Motion #1: Adopting the Sept. 14, 2012 Draft ERC Regulating Plan with amendments as follows:

SUMMARY SHEET

March 7, 2013 Approved Amendments to the Sept. 14, 2012 Draft ERC Regulating Plan

Staff recommended corrections to the Sept. 14 draft E. Riverside Corridor Regulating Plan:

Figure 1-3: East Riverside Corridor Roadway Type Map

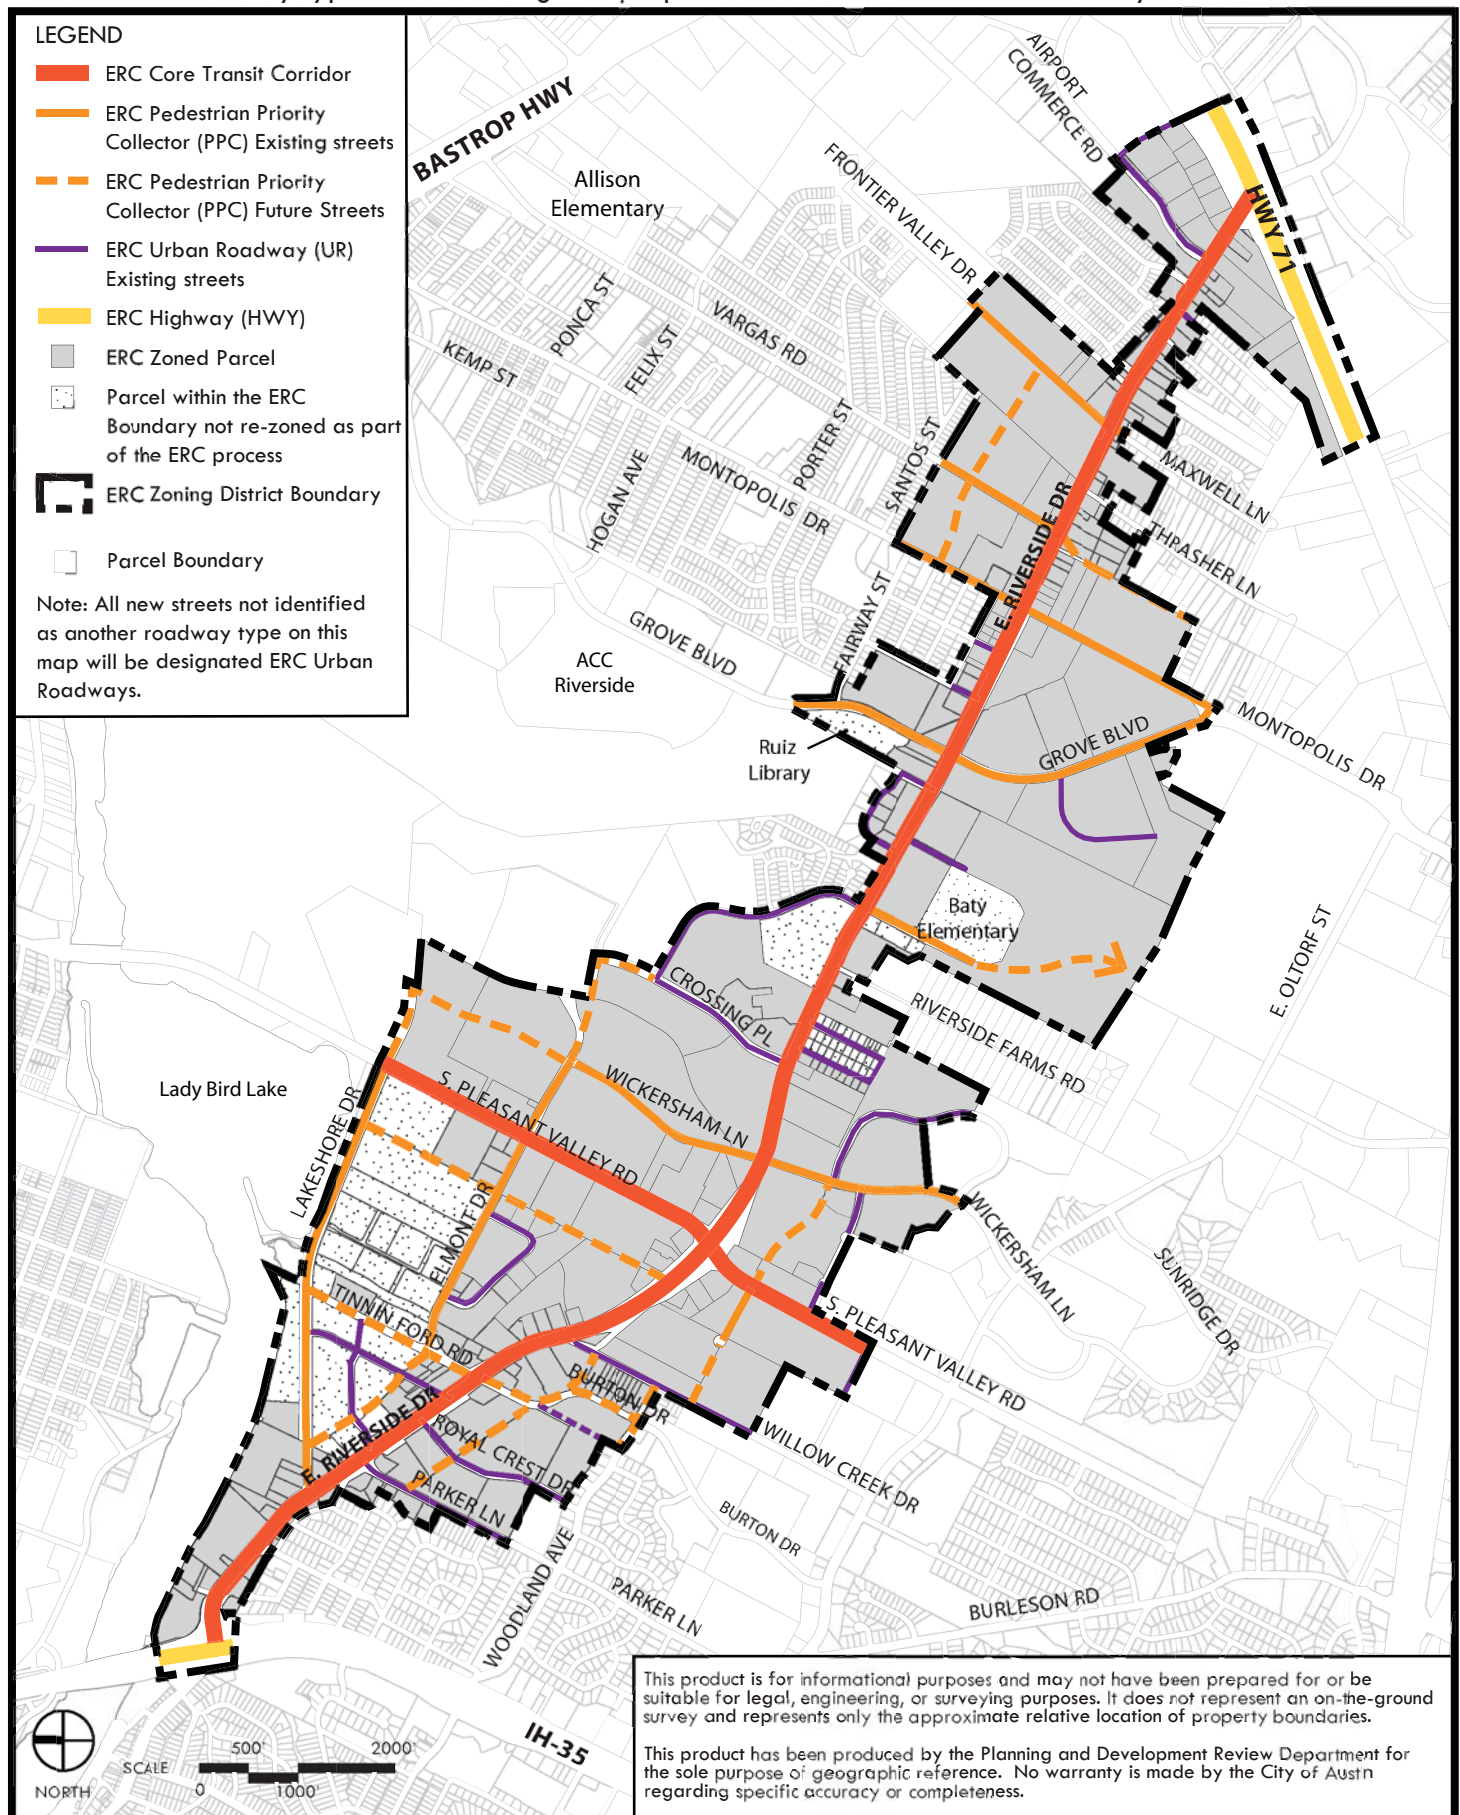
- C.2. P. 15, Modification to collector street map to account for an existing drainage way. See revised Figure 1-5: East Riverside Corridor Collector Street Map (Nov. 8, 2012 DRAFT – see attached) and associated Figure 1-3: East Riverside Corridor Roadway Type Map (Nov. 8, 2012 DRAFT– see attached).

Figure 1-14: East Riverside Corridor (ERC) Future Land Use Map (FLUM)

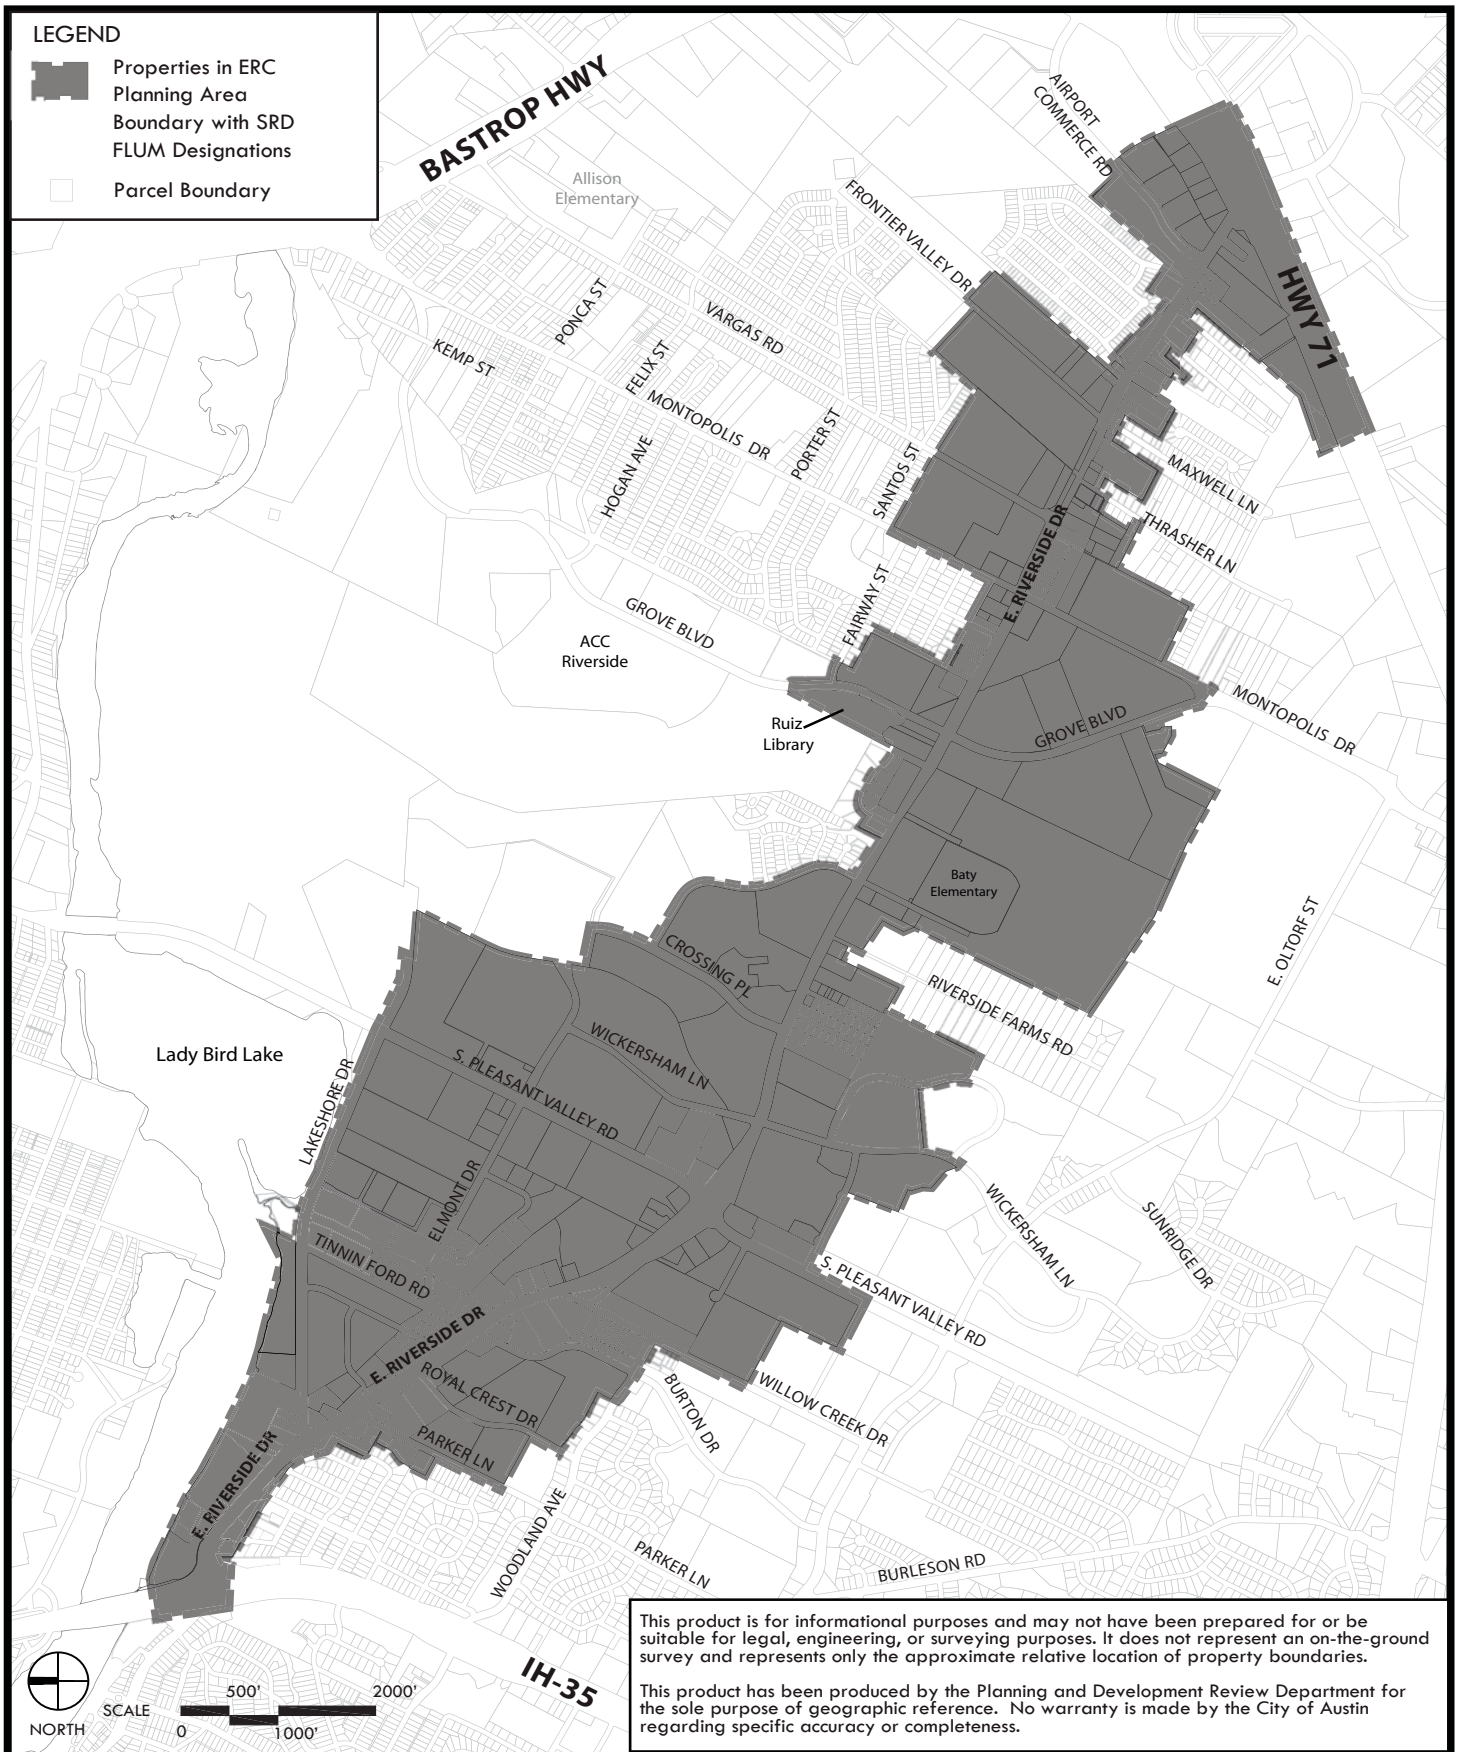
- A.3. P. 24. Add new Figure 1-14: East Riverside Corridor (ERC) Future Land Use Map (Nov. 8, 2012 DRAFT – see attached) (**Note:** Added for clarification purposes.)

Figure 1-15: Map of Properties with Drive-Through Facilities as of [adoption date, 2013].
Map of properties to which Subsection 2.3.5.B (Drive-Through Facilities) applies.

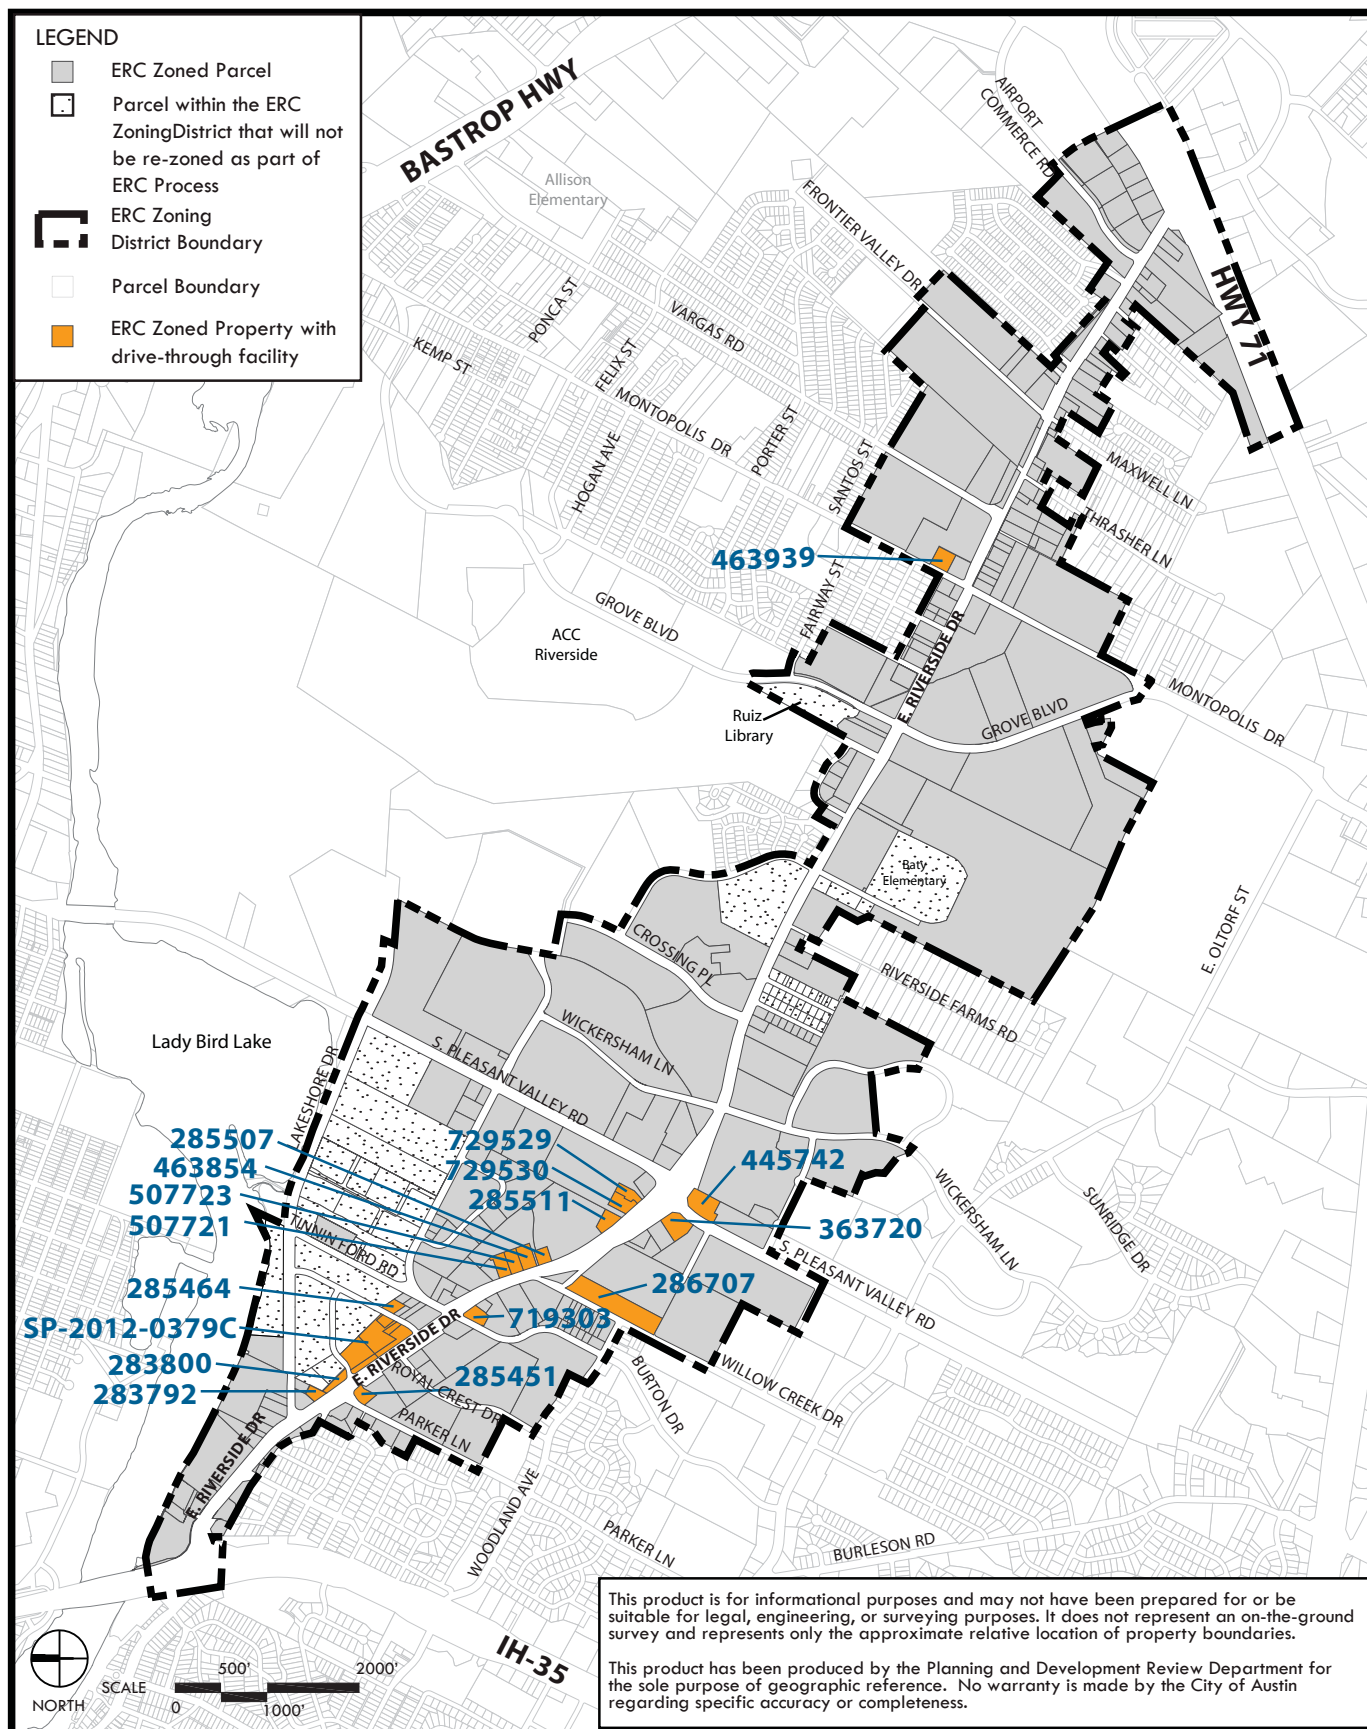
- D.1 P. 27, Subsection 2.3.5.B (Drive-Through Facilities) – Delete the text of Subsection B and replace with the following: “A property containing a drive-through facility legally constructed or permitted prior to [insert ERC Regulating Plan adoption date], is not subject to this Subsection 2.3.5.A. Construction on said properties can include the replacement of a drive-through facility, but construction will be subject to all standards in the ERC Regulating Plan according to the applicability standards in Section 1.2 Applicability. The number of drive-through bays or lanes cannot be increased from those existing as of the above date.” (**Note:** Staff deemed the original Subsection B language section repetitive and unnecessary.)
